Product Change Notification

January 29, 2019

Bourns® SRN Series Semi-Shielded Power Inductors

Wire Insulation Color Change for Select SRN Series

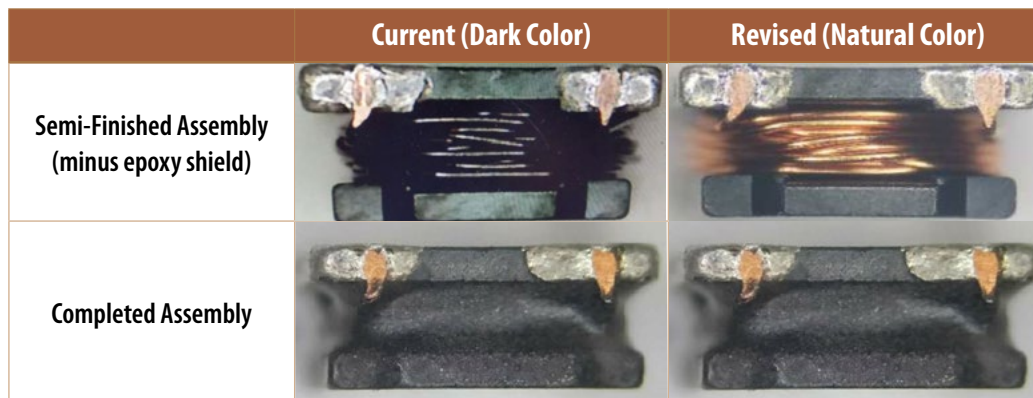
Bourns is making a change to the inductor wire insulation color of the SRN Series Semi-Shielded Power Inductors listed below. To better manage the flow of material sourcing, production and quality inspection, the appearance of the inductor wire insulation will be changed from a dark color to a natural color.

The form of the product will be changed. There will be no change to the fit, function, quality or reliability of the inductors. A list of affected part numbers is shown on page 2.
